FINAL PLAT PINE MEADOW ADDITION AN ADDITION TO WICHITA, SEDGWICK COUNTY, KANSAS

RE: SUB 2001-61 -- Final Plat of Pine Meadow Addition

At the regular meeting of the Subdivision Committee of the Metropolitan Area Planning Commission on Thursday, July 26, 2001, the above captioned plat was considered. The action of the Committee was to approve the final plat, subject to the following:

CASE NUMBER: SUB 2001-61 -- PINE MEADOWS ADDITION

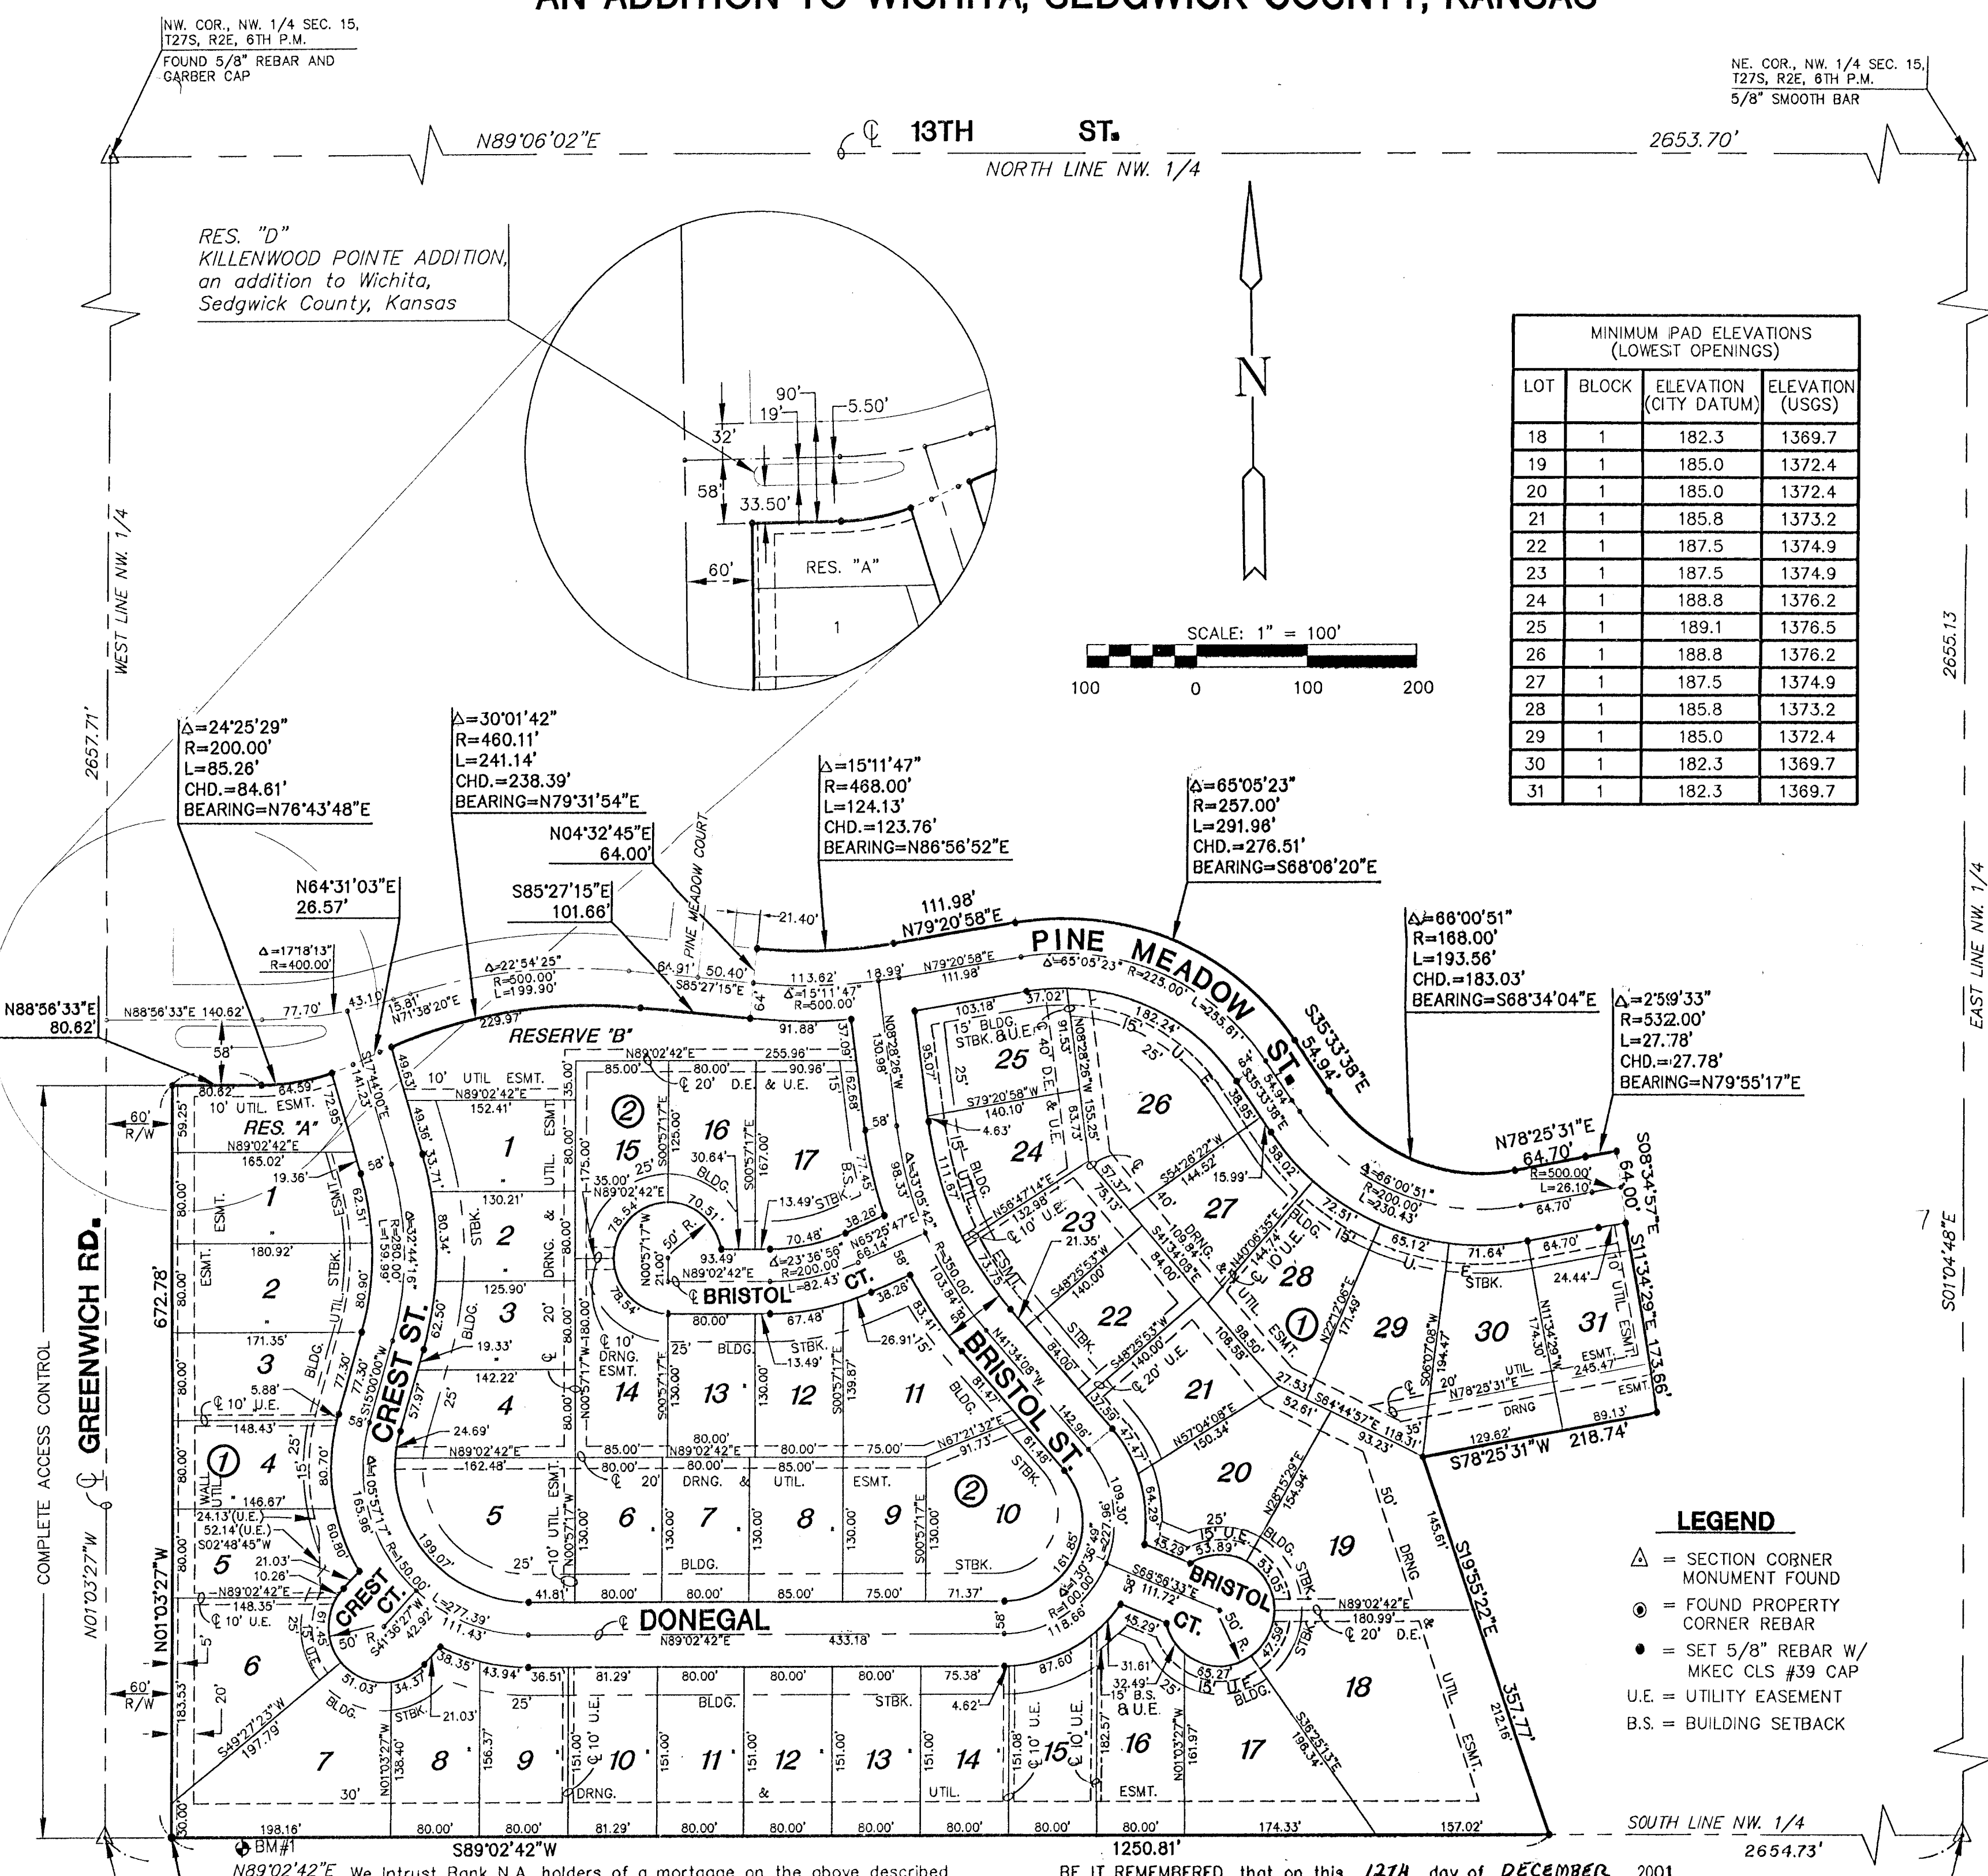
- D. City Engineering needs to comment on the status of the applicant's drainage plan. The drainage plan is approved.
- E. On the final plat tracing, the MAPC signature block needs to reference "J.D. Michaelis, Acting Chair".

- F. On the final plat tracing, the City Council signature block should be revised to denote "At the direction of the City Council" above the signature line of the City Manager.

- G. Complete access control shall be dedicated along Greenwich Road and denoted on the face of the plat.
- H. The Applicant shall guarantee the paving of the proposed streets.

- P. The City Fire Department/GIS needs to comment on the plat's street names. Pine Meadow should be replaced with Killenwood. Gatewood needs to be replaced with Hartmoor or Donegal. Gatewood Court needs to be replaced with Crest Ct (southwest corner) and by Bristol Ct (Southeast corner).

Donegal Lane needs to be revised to Donegal.
- Q. The wall easement needs to be referenced in the plat's text.
- R. A bearing needs to be added along the north line of Lot 19, Block 1.
- S. The centerline of Killenwood needs to be located along Greenwich Road.
- T. A right-of-way width needs to be added for the west end of Killenwood.
- U. The legal description needs to be corrected to remove lines that are repeated.

- Q. The wall easement needs to be referenced in the plattor's text.
- R. A bearing needs to be added along the north line of Lot 19, Block 1.
- S. The centerline of Killenwood needs to be located along Greenwich Road.

- T. A right-of-way width needs to be added for the west end of Killenwood.
- U. The legal description needs to be corrected to remove lines that are repeated.

The street names have been revised as requested.

- EE. The representatives from the utility companies should be prepared to comment on the need for any additional utility easements to be platted on this property. ***KGE has requested additional easements, which have been denoted on the final plat.***
